SKEP III Home Office Support Site Visit Report

Consultant	Wahib Medanat Consultant Engineer	Rep No.	22-21092021
Contractor	Dijlah Establishment Constr. Contracting	Tender No.	(11/2019/USAID/SKEP/3/S) Schools for a Knowledge Economy Project (SKEP) - Phase (3) Package (1, 2)
Site Name	Thahr Al Sarow Basic School for Boys- Jerash	Day/ Date	Tue. 21/09/2021
Duration of Project	450 Calendar Days	Total Project Budget	8,314,983.735 JD

(Figure: 17)

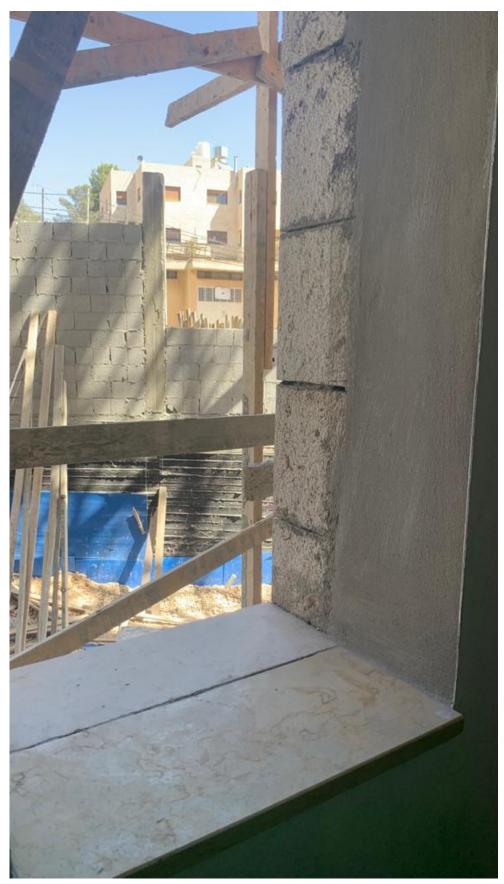
The Contractor started with painting works without completing the surrounded stone and concrete work
